UNITED STATES
DEPARTMENT OF THE INTERIOR
BUREAU OF LAND MANAGEMENT

SUNDRY NOTICES AND REPORTS ON WELLS
*Do not use this form for proposals to drill or to re-enter an
abandoned well. Use form 3160-3 (APD) for such proposals.*

PECOS DISTRICT CONDITIONS OF APPROVAL

OPERATOR'S NAME:	Cimarex Energy Co. of Colorado
LEASE NO.:	NM-100332
WELL NAME & NO.:	Da Vinci 7 Federal Com. No. 1
SURFACE HOLE FOOTAGE:	1180' FNL & 660' FEL
BOTTOM HOLE FOOTAGE	Same
LOCATION:	Section 07, T. 25 S., R 27 E., NMPM
COUNTY:	Eddy County, New Mexico

Figure 1 – Cross Sections and Plans For Typical Road Sections

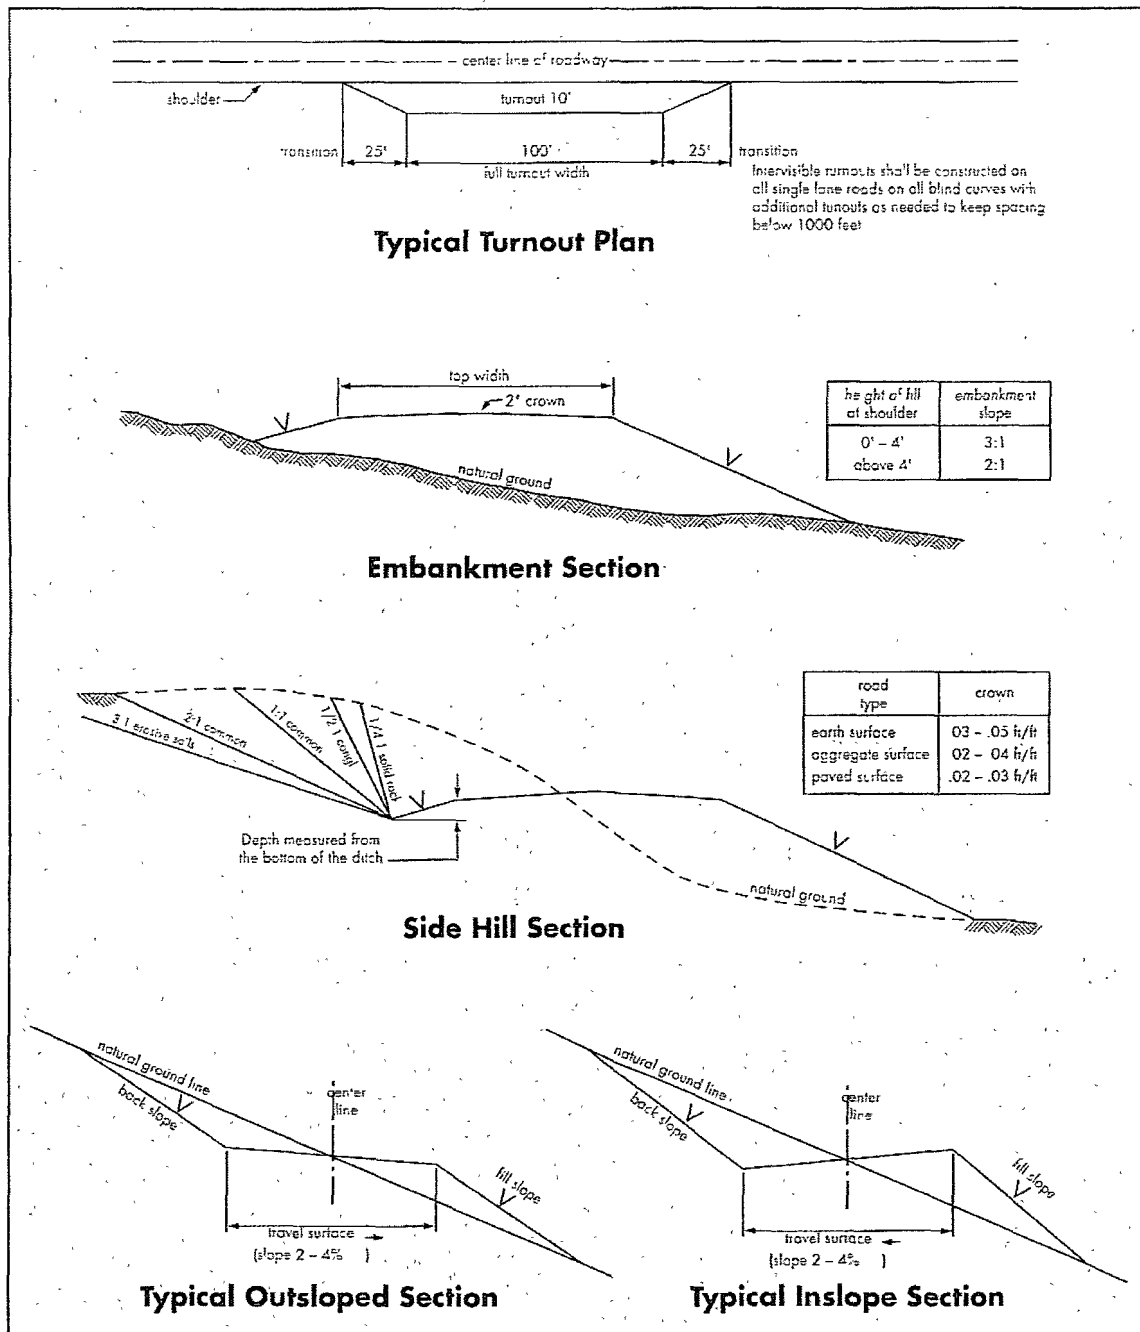
Crowning shall be done on the access road driving surface. The road crown shall have a grade of approximately 2% (i.e., a 1" crown on a 14' wide road). The road shall conform to Figure 1; cross section and plans for typical road construction.
